TULSA METROPOLITAN AREA PLANNING COMMISSION

For Meeting No. 2501

January 9, 2008 1:30 PM

Detail Site and Landscape Plan – The Dance Pointe, 9353 E. 95th Ct. South; Tract 1A, Part of Lot 3, Block 1; 9600 Mingo Office Park: OL/PUD

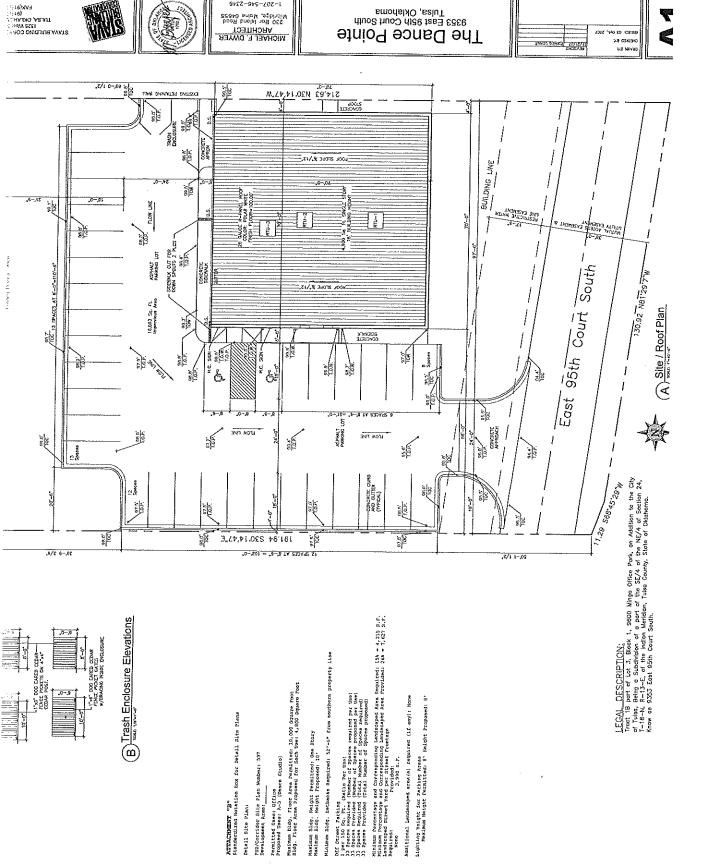
PUD development standards state that the internal access drive be setback no less than 50' from the residential development to the north. However, development standards allow deviations from this during detail site plan review. The applicant is proposing the internal access drive to be placed 43' 9 ¾" from the residential development area to the north. Because the applicant is seeking a reduction of 6' 2 ¼", there is a six-foot privacy fence located on the lot line in common with the R District and the access drive runs parallel to the R District, staff views this request as minor in nature having no significant impact on the residential development.

Therefore, staff recommends **APPROVAL** of detail site and landscape plans for Tract 1A, Part of Lot 3, Block 1; 9600 Mingo Office Park, PUD-597-3.

Detail Site Plan – Copper Oaks Office Park; 6321 E. 102nd St. S.; Lot 1, Block 1 – Copper Oaks Office Park; CS

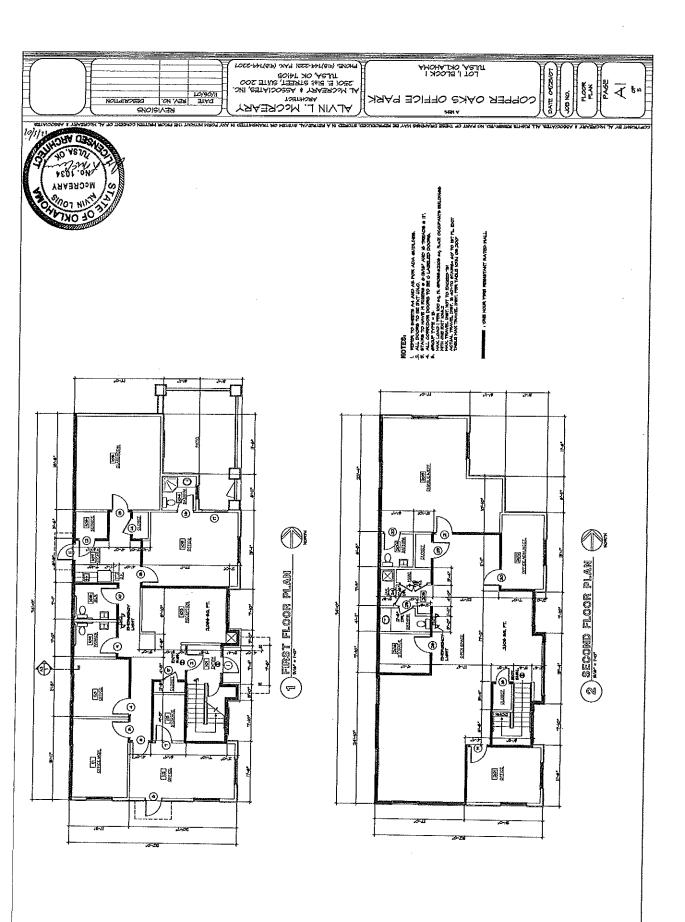
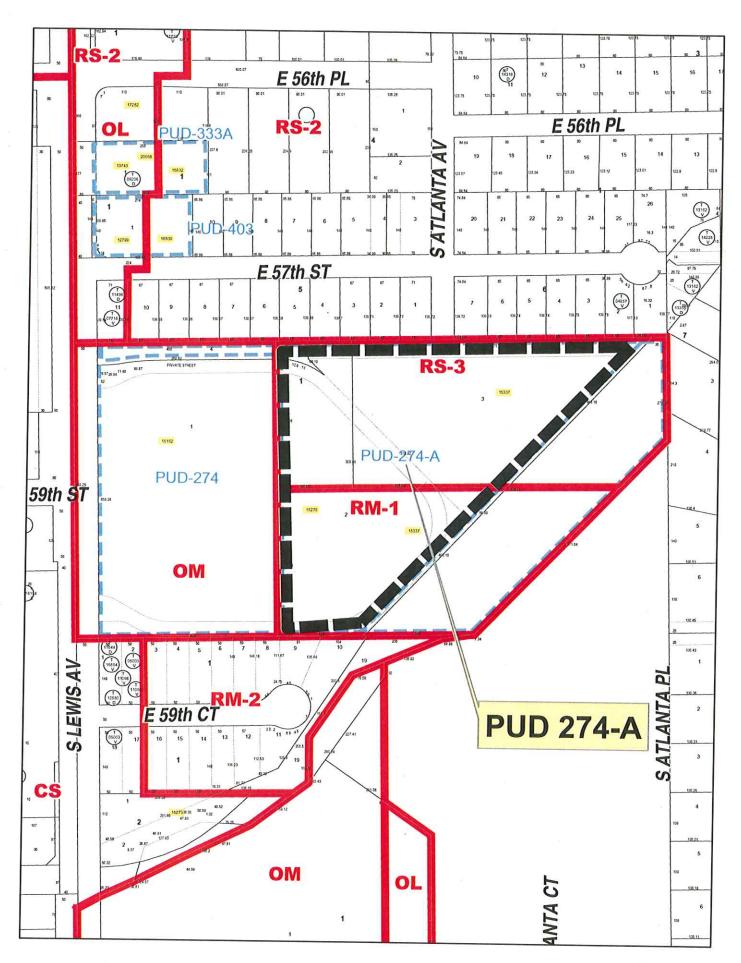
The detail site plan is missing required sidewalks along the mutual access easement along the eastern boundary of the lot, and along South 102nd Streets as required by PUD development standards. However, staff did verify with the applicant that sidewalks will be added to the site plan, prior to approval by the TMAPC staff.

Therefore, staff recommends **APPROVAL** of detail plan for PUD-431-C - Copper Oaks Office Park subject to the following minor revisions to the detail site plan submitted: add sidewalks along east boundary of the PUD/mutual access easement with Lot 2. Block 1 – South Tulsa Baptist Church Extended (plat no. 6034) and along 102nd Street South

PUD-678-2: Minor Amendment – 7516 East 97th Street; Lot 4, Block 2,

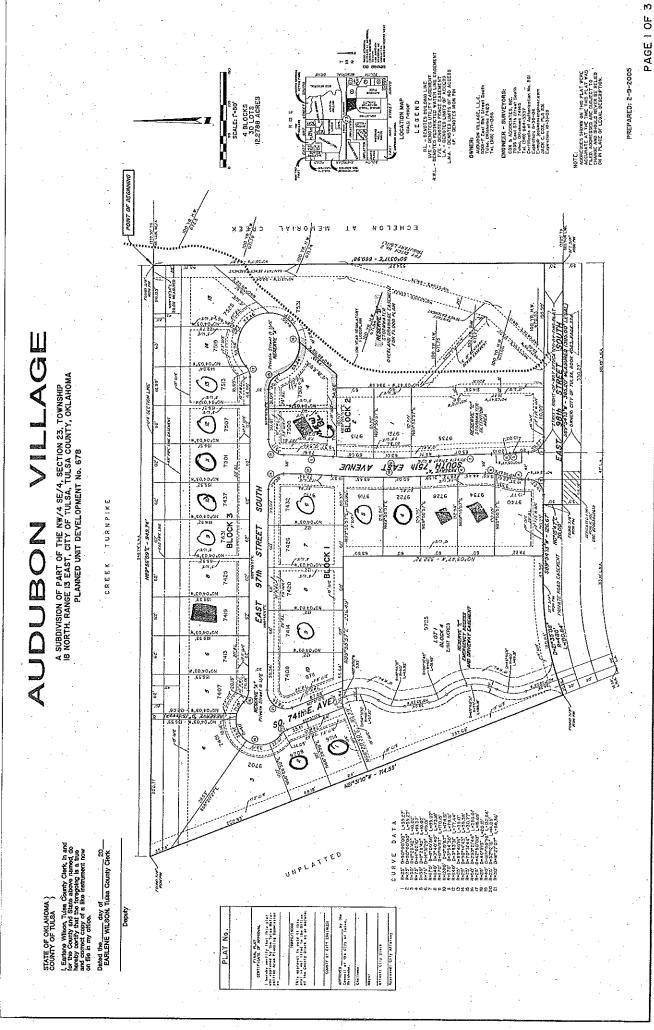
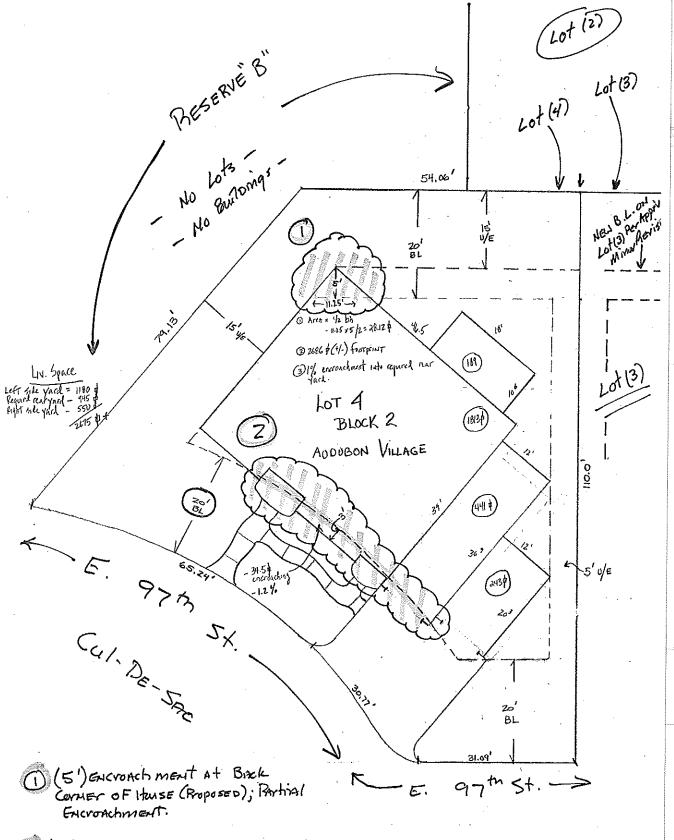
The applicant is requesting two minor amendments to PUD 678 for the purpose of allowing a five foot encroachment into the rear yard of a lot leaving a setback of 15 feet from the south property line and a minor amendment to reduce the required front setback from 20 feet to 17 feet.

The proposed rear yard encroachment is to accommodate a planned residential single-family dwelling. The 28.12 square foot encroachment is located on the left rear corner of the lot and is approximately 1% (+/-) of the total footprint of the proposed structure. The nearest lot immediately adjacent and to the east of the proposed encroachment is Reserve B of the PUD and contains a FEMA protected 100-year regulatory floodplain with no lots or buildings proposed or permitted. On September 9, 2007 the TMAPC approved a minor amendment request for Lot 3, Block 2 Audubon Village, also reducing the rear setback from 20 feet to 15 feet. If approved, this request will have no affect on the lot adjacent to the south, Lot 2, Block 2 of the PUD, and is consistent with the previously approved minor amendment PUD 678-1.

The applicant is also requesting a minor amendment to reduce the required front setback from 20 feet to 17 feet. Since this lot is the last house located on a culde-sac, a request to allow a reduction of 3 feet would appear to have little to no impact on the corner lot immediately adjacent to the west. Again, Reserve B of the PUD, a FEMA protected 100-year regulatory floodplain and over-land drainage easement is adjacent to the east. By asking for a reduction of less than 5 feet, and the secluded location of the lot, staff also sees this request as minor in nature and consistent with the intent of the PUD.
